August 9, 2016

Re: Arborist Review Tree Permit #2016-ARP-0003_Baptie, Review and Recommendations
Site: Wellington Hills Construction property, 3580 NE 162 St, Lake Forest Park, WA 98155

Figure 1: Tree Protection Fence Drawing.

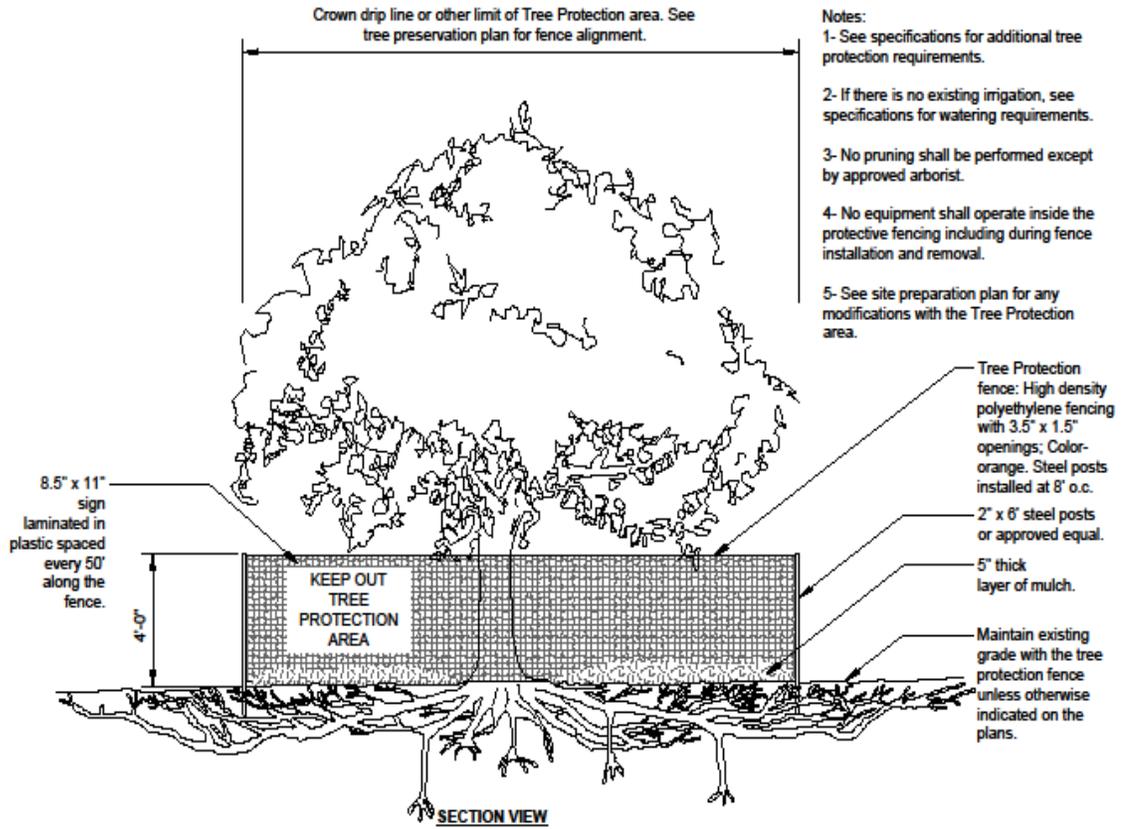
The Tree Protection Fences need to be clearly marked with the following or similar text in four inch or larger letters:

Refer to Figure :1 Tree Protection Fence Diagram.
